Access Compliance Report

Public Rights-of-Way

(Curb Ramps)

Intersection ID: 42494	Main Street: BULLOCK_GREENWAY_BV	Cross Street: TOLLESON_AV	Location: SE
ADA ID: C466EF7FA975	Ramp Type: PerpDiag	Initial Pass/Fail: Fail	Overall Compliance: No
Codes/Mitigation Info/Possible Solution		Field Measurements/Component Compliance	
Severity Score: 8.75

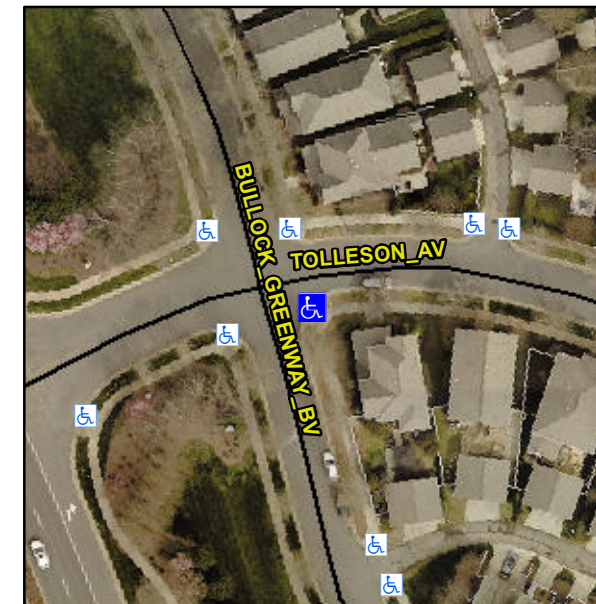
Not Found, R304.5.1

Compliance	Description	Data	Compliance	Description	Data
N/A	Ramp Length (in)	79.5	Yes	Ramp Slope (%)	5.4
No	Ramp Width (in)	44.0	Yes	Ramp XSlope (%)	1.3
N/A	Flare Type LT	N/A	N/A	Flare Type RT	N/A
N/A	Flare Slope LT (%)	N/A	N/A	Flare Slope RT (%)	N/A
N/A	Flare Traversable LT?	N/A	N/A	Flare Traversable RT?	N/A
N/A	Landing Length (in)	N/A	N/A	DWS Provided?	N/A
N/A	Landing Width (in)	N/A	N/A	DWS Contrast?	N/A
N/A	Landing Slope (%)	N/A	N/A	DWS Length (in)	N/A
N/A	Landing X Slope (%)	N/A	N/A	DWS Full Width?	N/A
N/A	Landing Curb? (Y/N)	N/A	N/A	DWS Offset (in)	N/A
N/A	Shared Landing?	N/A			
N/A	Gutter Ponding?	N/A	N/A	Gutter Slope (%)	N/A
N/A	Gutter Lip Ht (in)	N/A	N/A	Gutter X Slope (%)	N/A
N/A	Painted X Walk1?	No	N/A	Painted X Walk2?	No
	X Walk 1 Direction	To N		X Walk 2 Direction	To W
N/A	X Walk 1 Width (in)	N/A	N/A	X Walk 2 Width (in)	N/A
	X Walk 1 Slope (%)	0.0		X Walk 2 Slope (%)	1.0
	X Walk 1 X Slope (%)	0.6		X Walk 2 X Slope (%)	0.1

Remove & Replace Curb Ramp With Two New Directional Ramps or Equivalent.
